CALL NO. 206  
CONTRACT ID NO. 121354  
ADDENDUM # 2

Subject: Trigg-Marshall Counties, 121GR12D054-BRO  
Letting November 16, 2012

- (1) Revised - Plan Sheets - R1, R2A, R2B, R7, R8, R13, R14, R31, R32, R33, R35, R36, R38, R40, R41, R83, R85, X14, X15, X16, X18, X20, X21, & X26
- (2) Deleted - Plan Sheets - R25, R26, & R86 through R90
- (3) Revised - Front Page of Proposal
- (4) Revised - Completion Date - Page 4 of 177
- (5) Added - Dynamic Pile Testing - Pages 78(a)-78(c) of 177
- (6) Added - Static & Pseudo-Static Pile Testing - Page 96(a) of 177
- (7) Revised - Material Summary - Pages 130-132(a) of 177
- (8) Revised - Bid Items - Pages 173-175 of 177

BRO 0801 (093)  
RECONSTRUCT US 68 / KY 80  
GRADE & DRAIN PLANS

COUNTY OF	ITEM NO.	SHEET NO.
MARSHALL TRIGG	1-180.75	R41

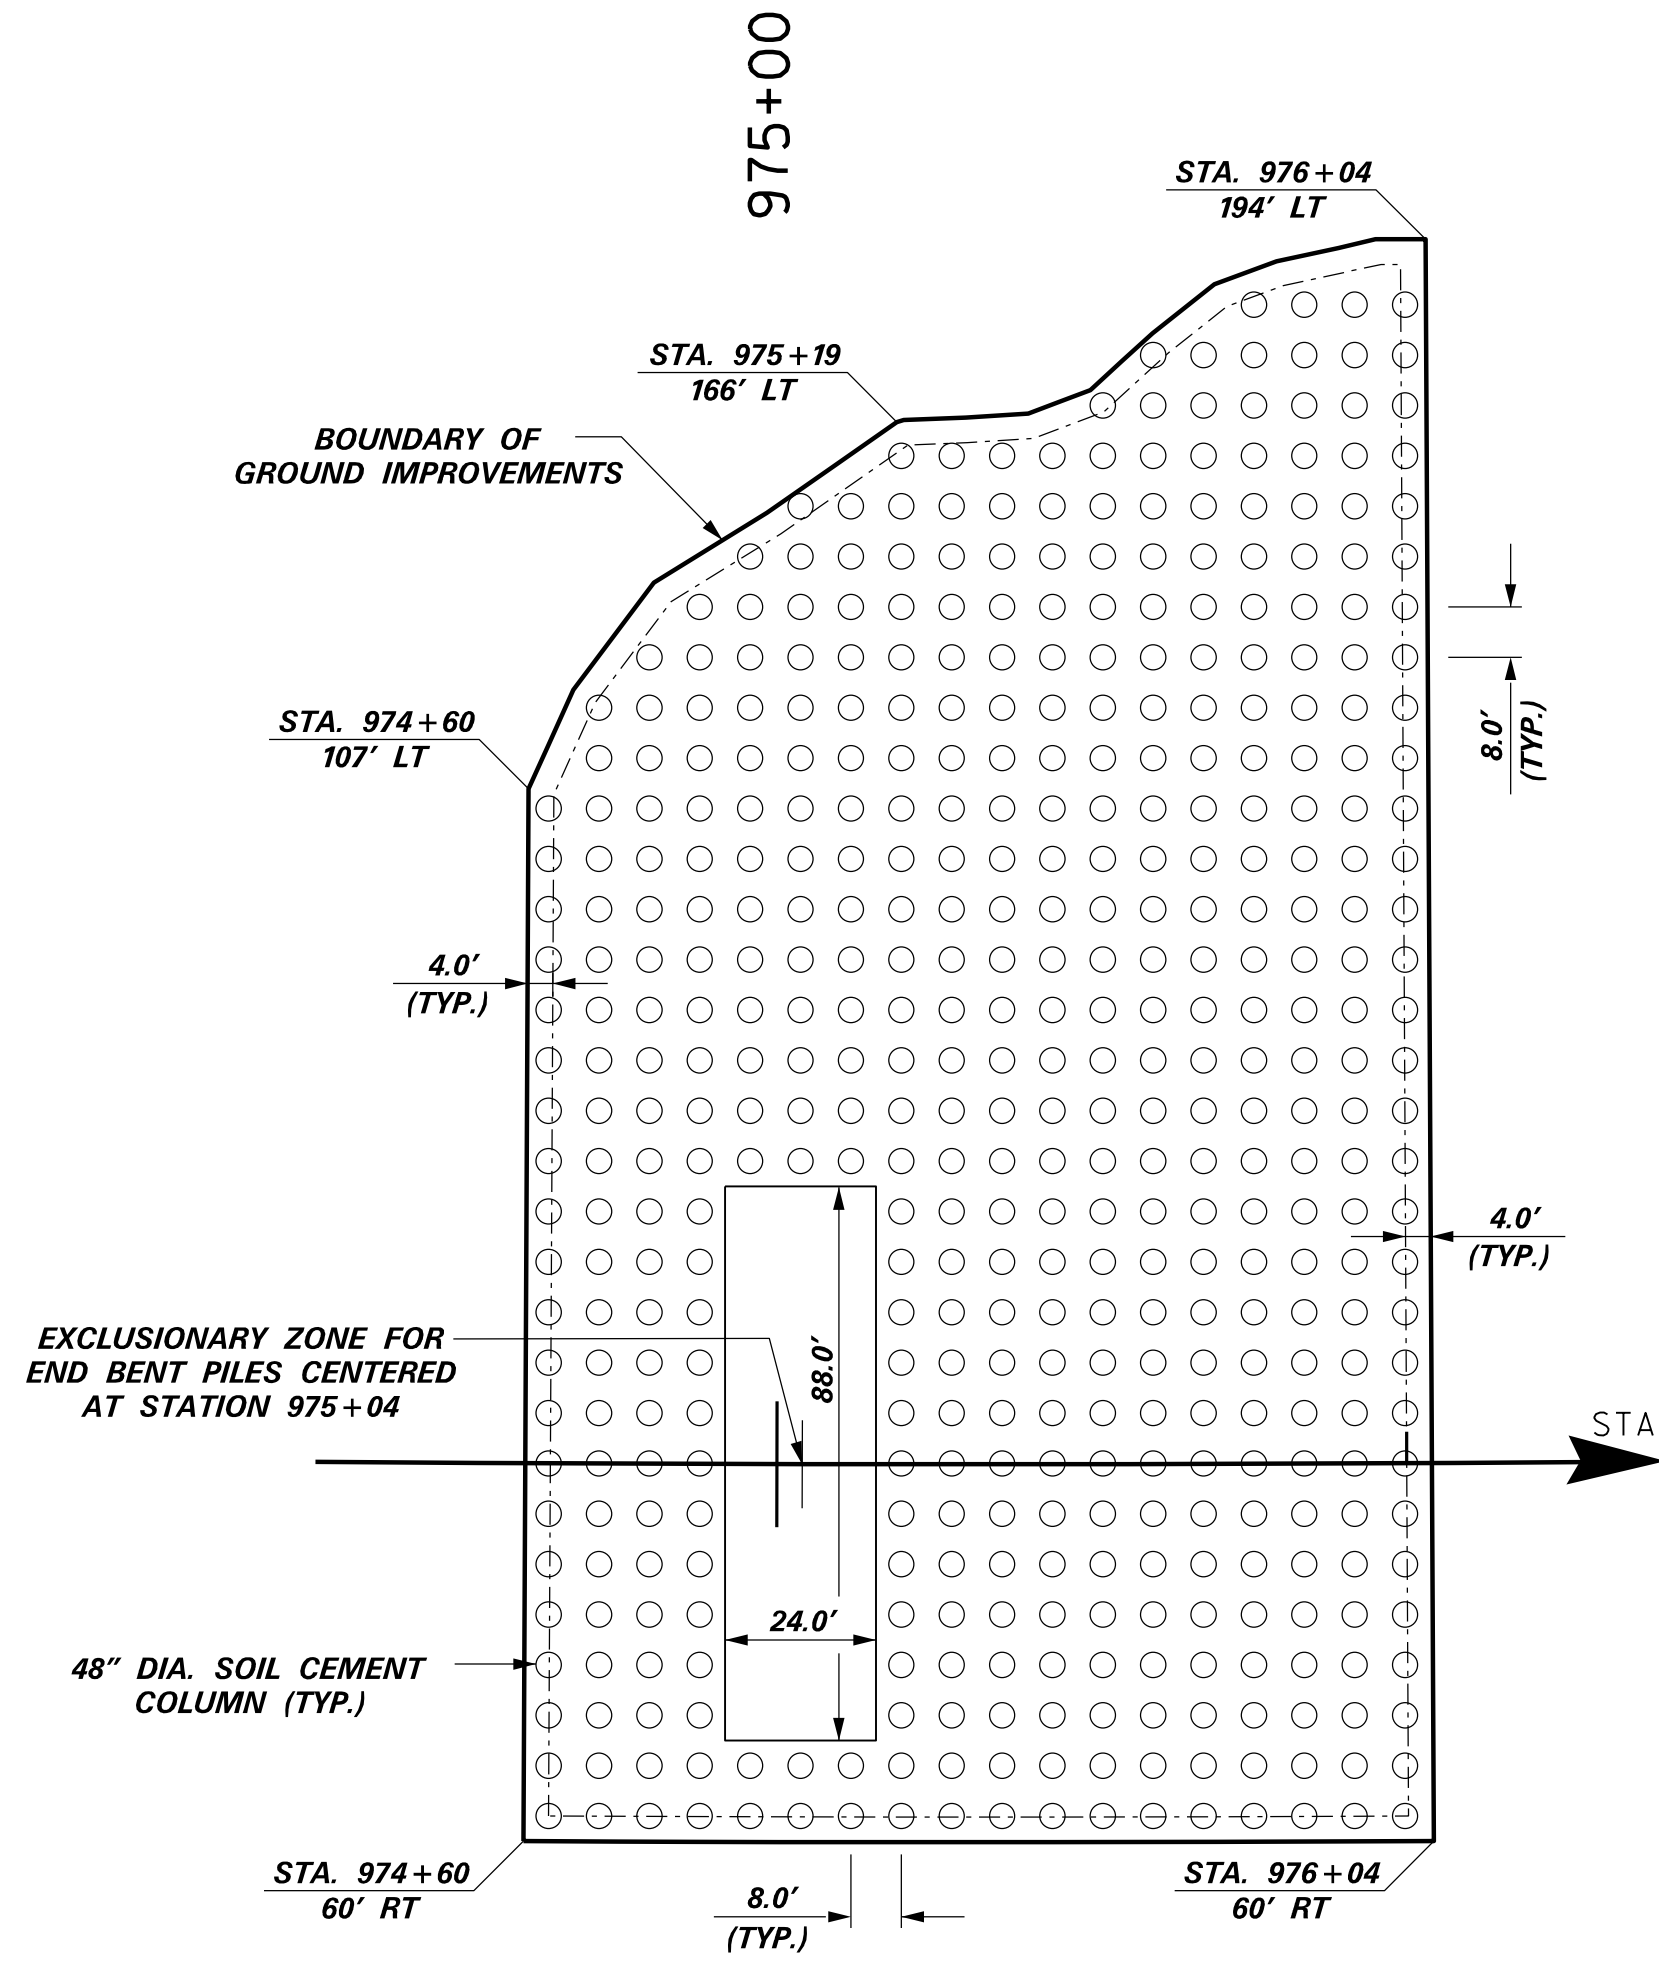
△ REVISED 10-31-12

16. In addition to the required CU triaxial testing, index testing shall also be performed on the proposed materials used for embankment construction above Elevation 363 feet. These index tests shall include Atterberg Limits in accordance with AASHTO T89 and T90 and Gradation in accordance with AASHTO T88. Soils which classify as non-plastic (NP) will not require Atterberg Limits. A minimum of one (1) set of index testing shall be completed per 10,000 cubic yards of embankment or for every change in either material type or borrow source. The Contractor shall randomly sample from the borrow source and the samples for index testing must come from the 10,000 cubic yards of embankment that the samples represent. If the embankment material is placed prior to receiving the results of the index testing and the index tests show that the material is unacceptable, then the Contractor may have to remove that material at no expense to the Department. Soils that classify in accordance with the Unified Soil Classification System as GW, GP, GM, GC, SW, SP, SM, SC, CL or ML will be accepted as embankment material above Elevation 363 feet. Also, in accordance with the Unified Soil Classification System, soils that classify as CH, MH, OH, OL or Pt will not be accepted to be used as embankment material above Elevation 363 feet. If the classification of the samples is different than the classifications of the triaxial samples, additional CU triaxial testing may be required at the discretion of the Department and at no additional cost to the Department. In addition, CU triaxial and index testing may be waived on embankment materials above Elevation 363 feet if granular embankment meeting the requirements in Geotechnical Note Number 11 is utilized higher than the required minimum elevation. Laboratory testing needs to be performed by a firm pre-qualified by KYTC for Geotechnical Laboratory Testing and AASHTO Materials Reference Laboratory (AMRL) Accredited for AASHTO T88, T89 and T90. Prior to beginning testing, consult the Geotechnical Branch to ensure that a lab is accredited or certified. The cost of obtaining the samples and performing the laboratory tests shall be incidental to the unit price for Embankment in Place.

17. The bridge approach embankments shall include 'granular pile cores' to facilitate installation of the foundation systems. Construction of the pile cores shall be in accordance with KYTC Special Provision No. 69, Standard Drawing Nos. RGX-100 and RGX-105 (with the exceptions described below), and Section 206 of the current Kentucky Department of Highways Standard Specifications for Road and Bridge Construction. Erodible materials shall not be used in construction of pile cores. An exception to the KYTC Standard Drawings RGX-100 and RGX-105 is the structure granular backfill. Behind the abutment of the Lagoon Bridge End Bents, this structure granular backfill shall extend 8 feet horizontally back into the embankment from the bottom of the pile cap then extend up a 1H:1V slope vertically away from the abutment. This shall be done as shown in the project plans. Another exception to the KYTC Standard Drawings RGX-100 and RGX-105 is near End Bent 2 of the Lagoon Bridge. At this End Bent, it is required that the pile foundations be installed after the granular embankment with the granular pile core is constructed to the Elevation 363 feet and before any additional embankment soils are constructed. Refer to the structure plans for the Lagoon Bridge for detailed construction sequence requirements.

COUNTY OF	ITEM NO.	SHEET NO.
MARSHALL TRIGG	I-180.75	R83

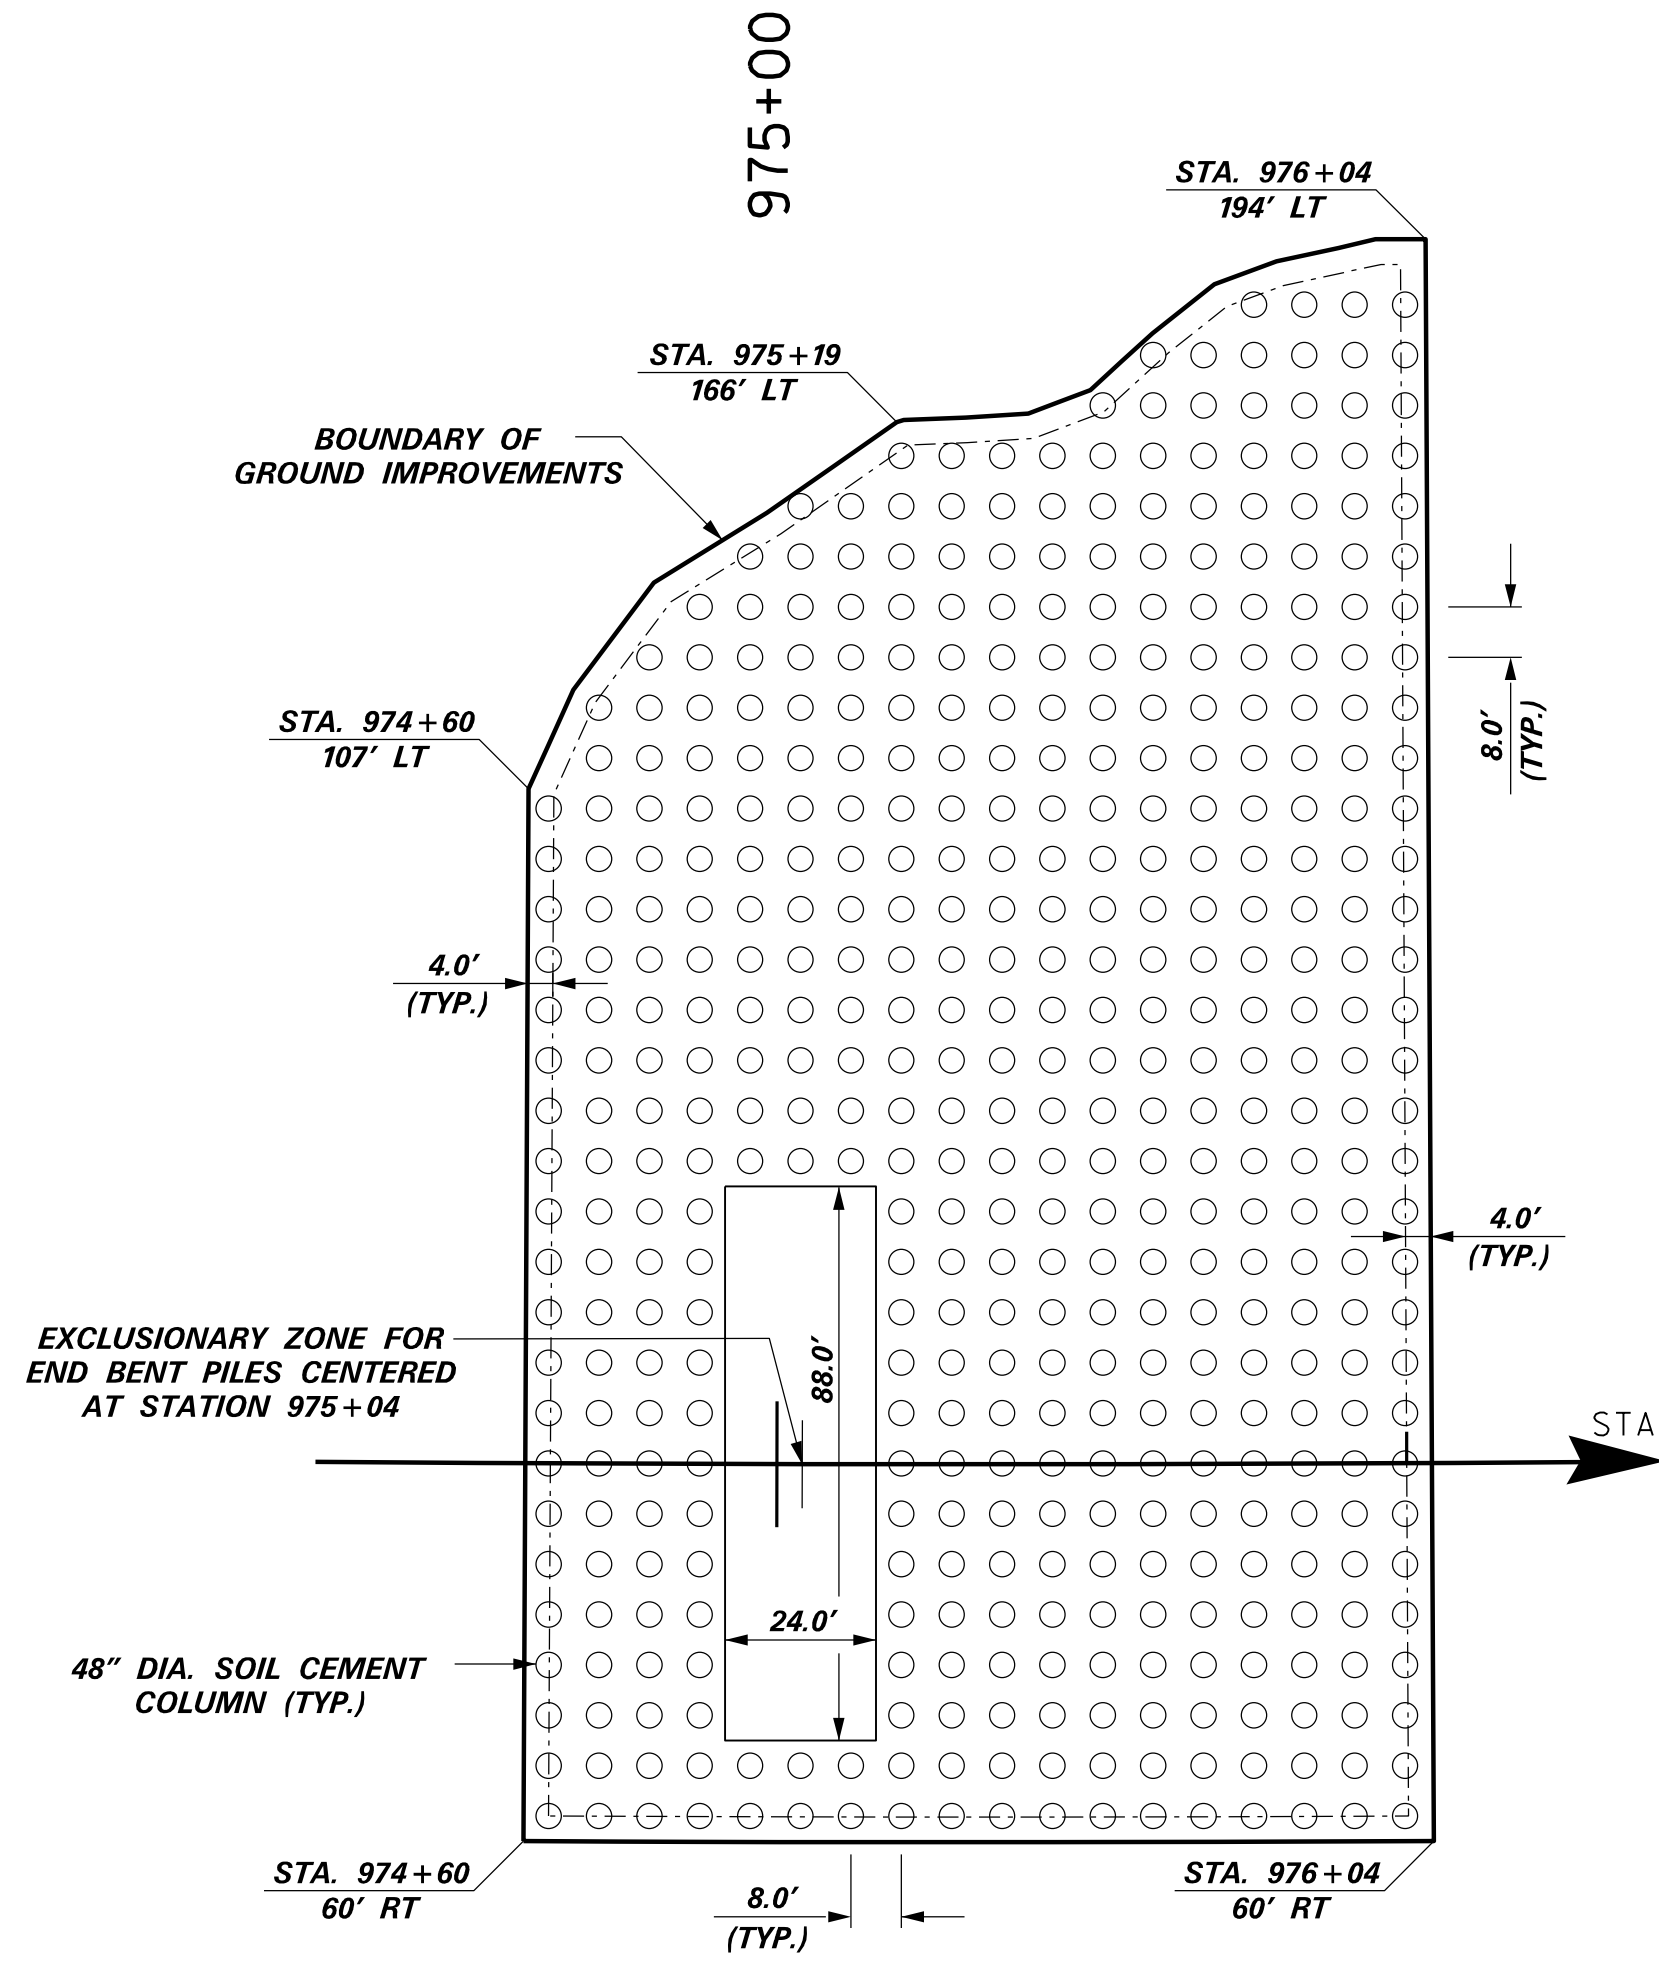
△ REVISED 10-31-12

**CONTINGENCY QUANTITY = 2,500 C.Y.**  
**TOTAL PLAN QUANTITY = 12,500 C.Y.**
